Glen Innes Wind Farm

*Modification Assessment
(07_0036 MOD 4)*

September 2020

Figure 4 | Residential clusters and visual ratings of non-associated residences within 3.6 km of a project turbine

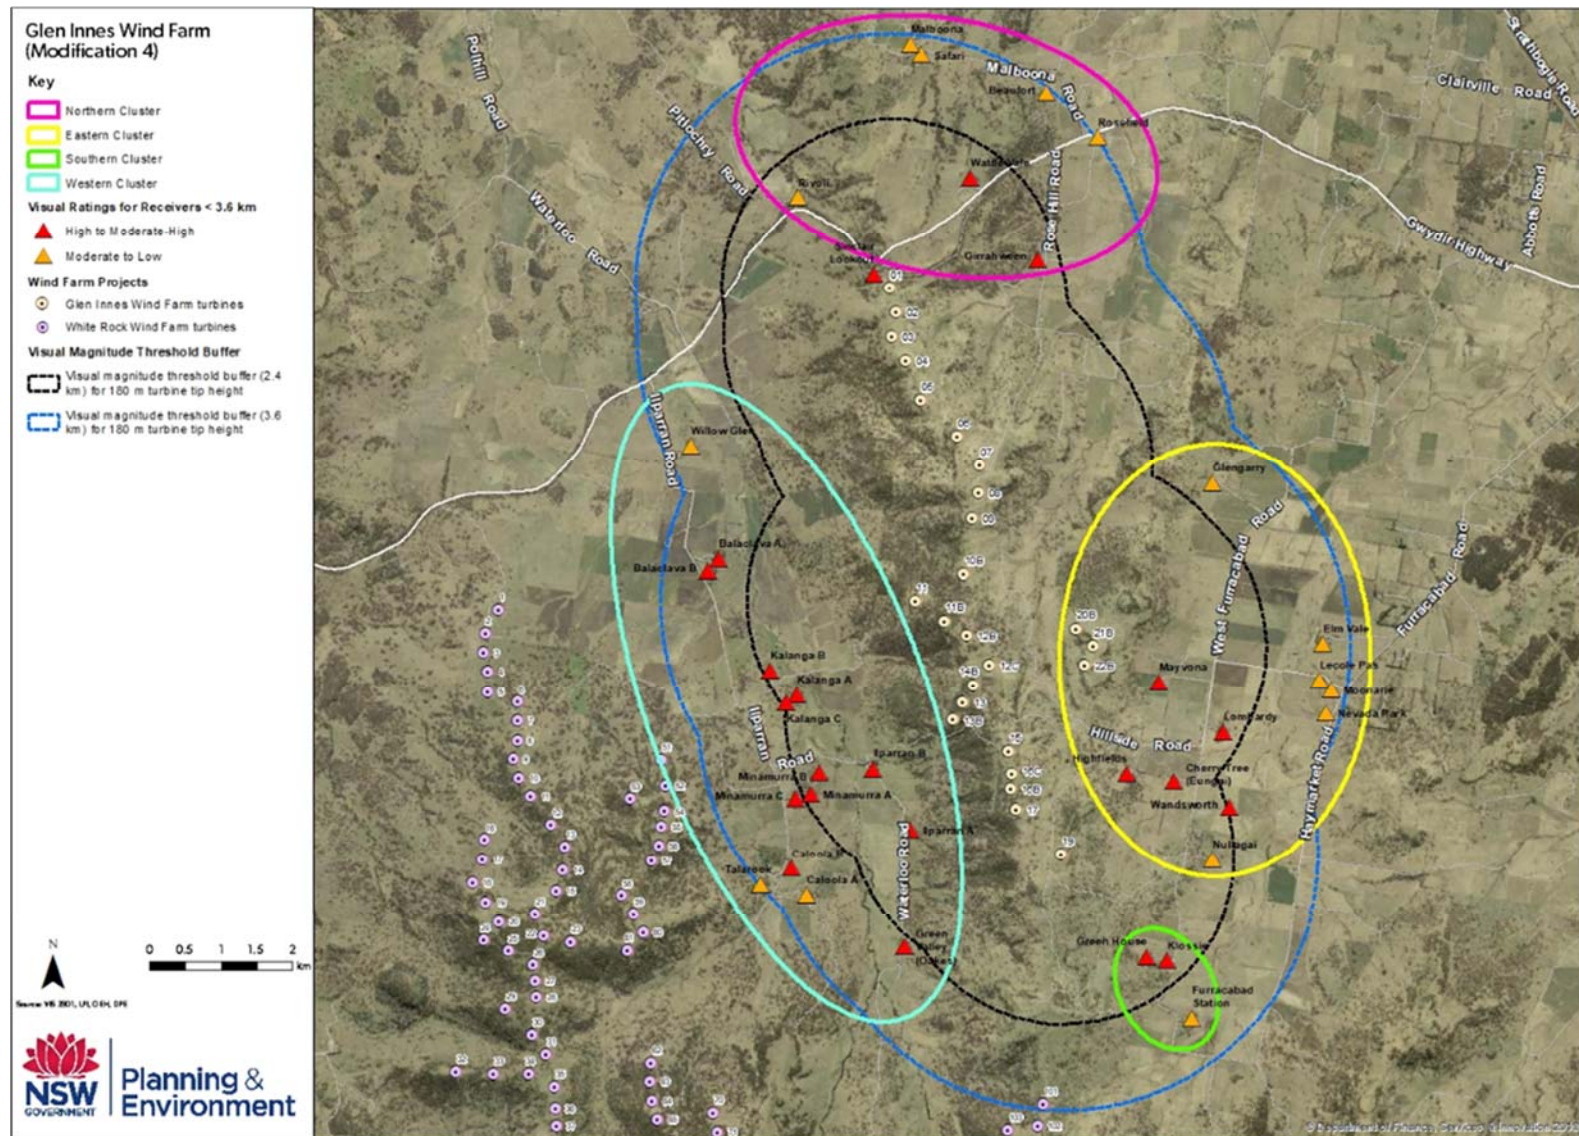
The Department has assigned the 36 non-associated residences into 4 separate residential clusters (see **Figure 4** below). Residences within each cluster are broadly grouped to reflect comparable geographical positioning and locational characteristics which result in potentially similar visual impacts from project turbines.

The Department assessment identified that high and moderate/high ratings represent over 58% of the residences assessed within 3.6 km of project turbines. Importantly, of the 21 non-associated residences that were provided a moderate/high or high visual rating, 15 are located within 2.4 km of a project turbine and require detailed consideration under the Bulletin (see **Figure 4**).

As evident in **Figure 4**, the visual impacts of the modification are not confined to just one or two areas around the site and that larger turbines are likely to impact the majority of residences surrounding the site.
